Ordinary Meeting of Council

ITEM 9.1 DA.2022.1551 - 45 SINCLAIR ROAD, PRIMROSE VALLEY,
APPLICATION FOR DUAL OCCUPANCY

ATTACHMENT 1 ASSESSMENT REPORT - DA.2022.1551 - 45 SINCLAIR ROAD
PRIMROSE VALLEY

DELEGATED REPORT - DA.2022.1551

Figure 1: Application site

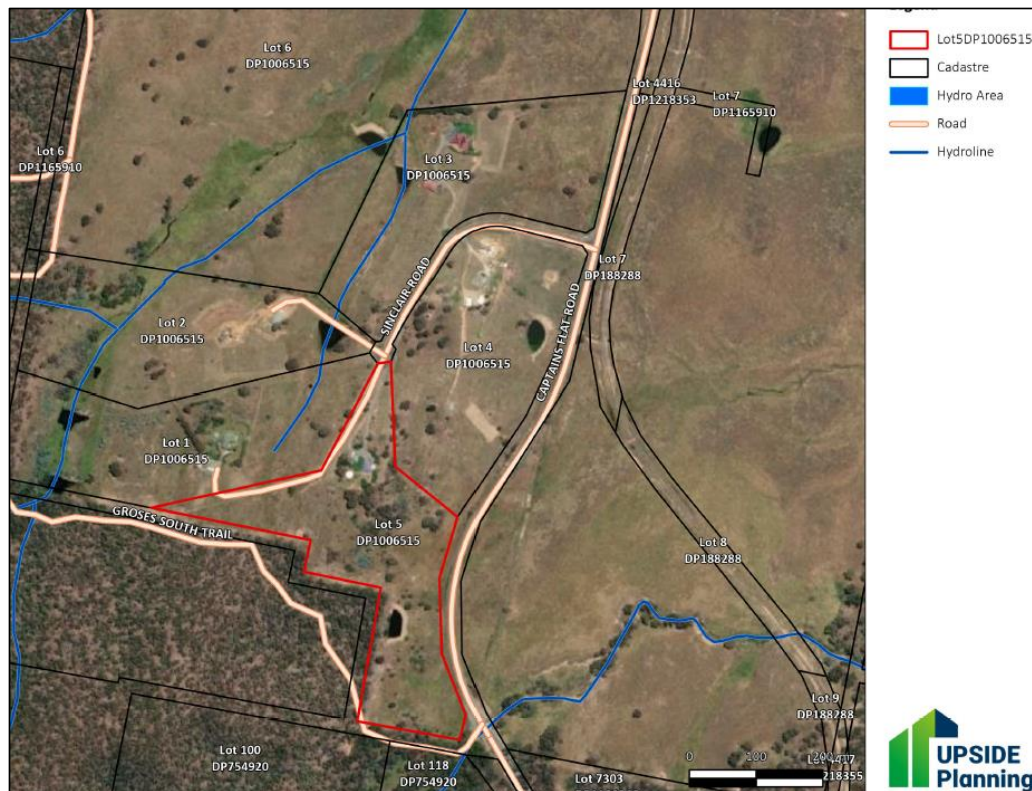
Although the minimum lot size in the locality is 80ha, the application site is 8.5ha in area.

The site is not used for primary production.

Figure 2: Terrestrial Biodiversity

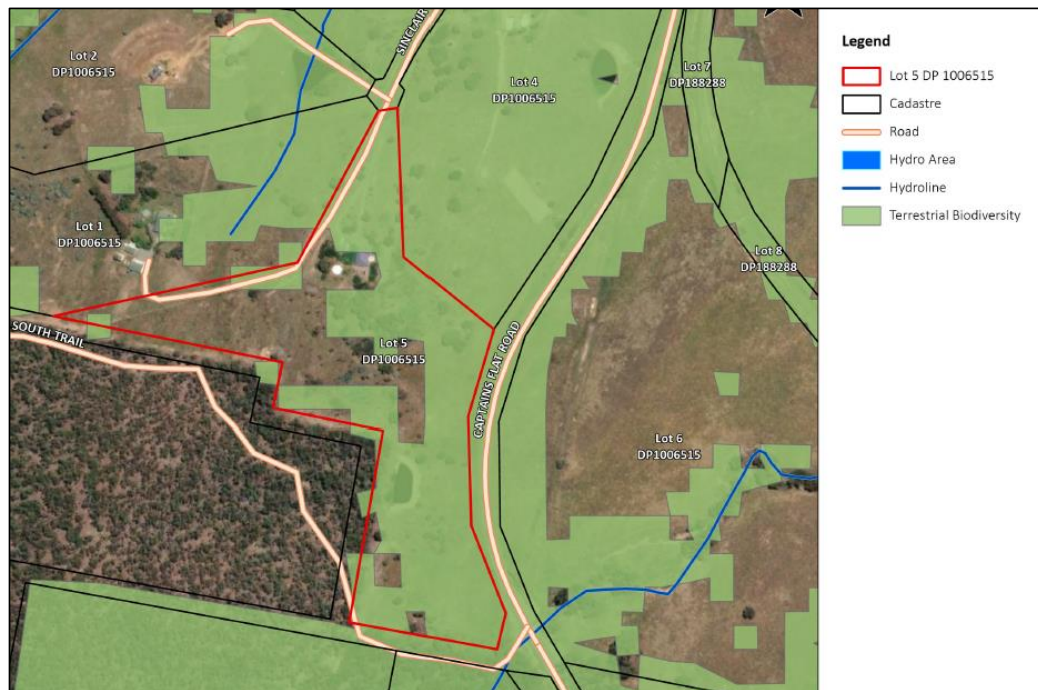
This clause applies to land identified as Terrestrial Biodiversity. Figure 2 below shows the land identified as likely to contain ecological value.

Subclause (4) states that “development consent must not be granted to development on land to which this clause applies unless the consent authority is satisfied that:

Figure 3: Riparian land and watercourses

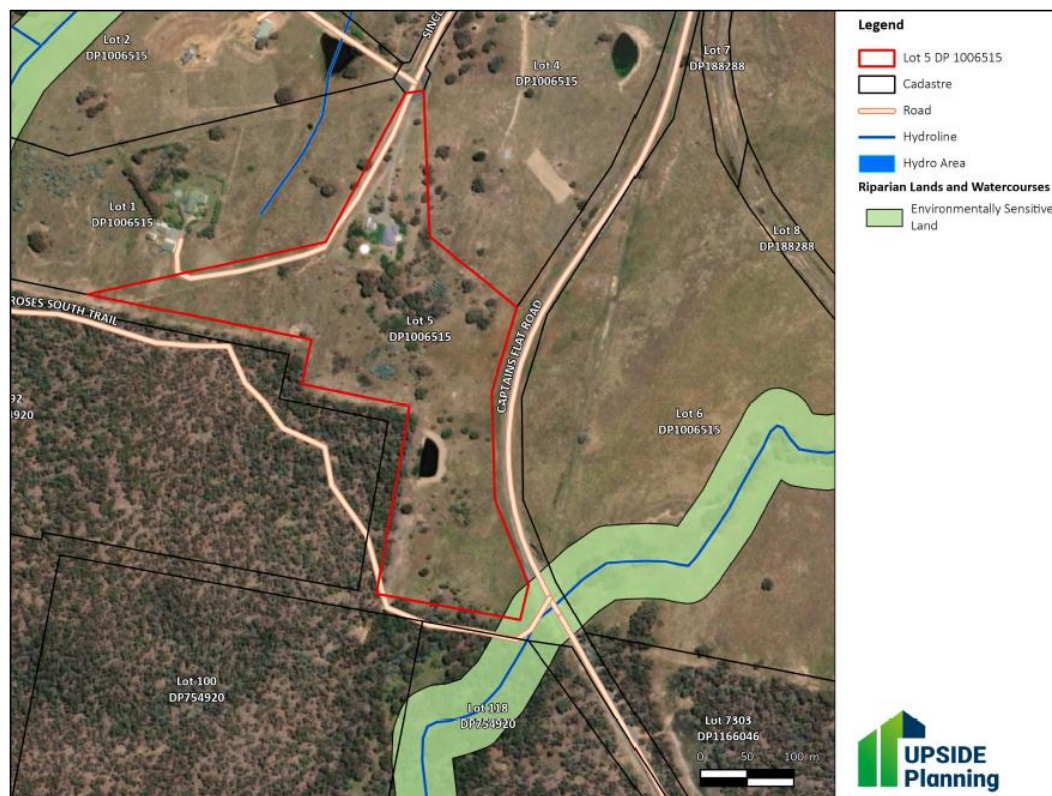
Figure 3 below provides the PLEP 2014 Riparian land and watercourses map. It shows that the proposed dual occupancy is located outside the mapped area. Although not part of the subject development application, the recently constructed motocross circuit appears likely to impact the adjacent watercourse.

This excavation and earthworks do not have approval.

Figure 4: Elevation Map

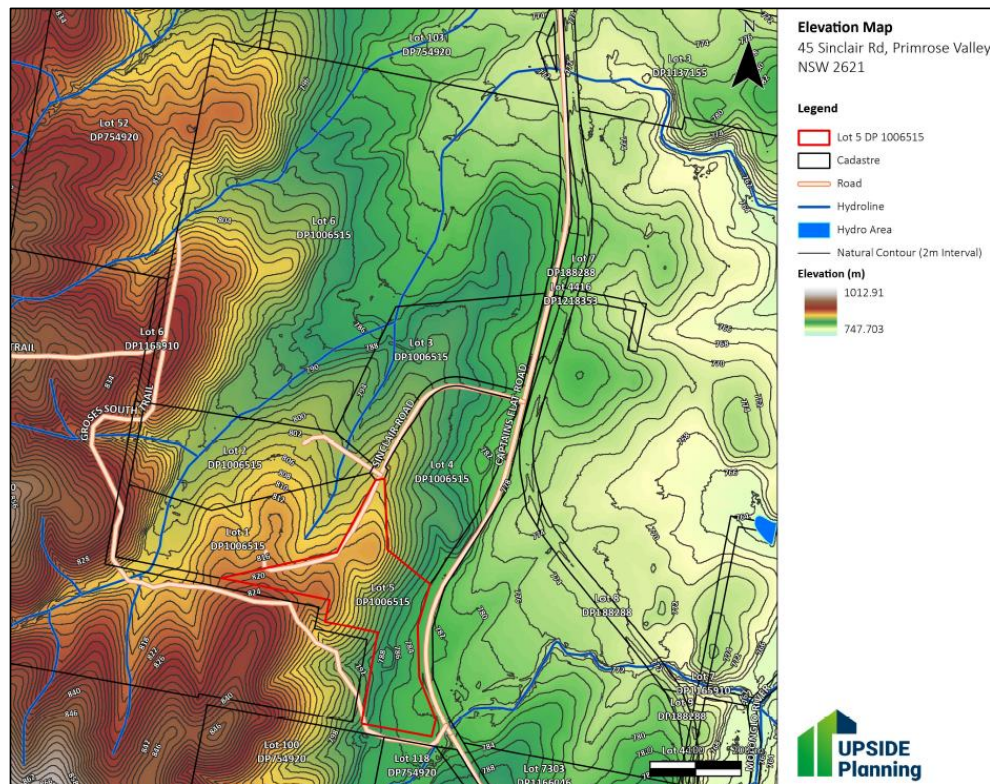
Figure 4 below, an elevation map, illustrates the visual prominence of the site.

Existing development on the application site, some of which is underway, has an adverse visual impact on the rural landscape. The proposed development would further degrade the visual quality of the locality and is an overdevelopment of the site.
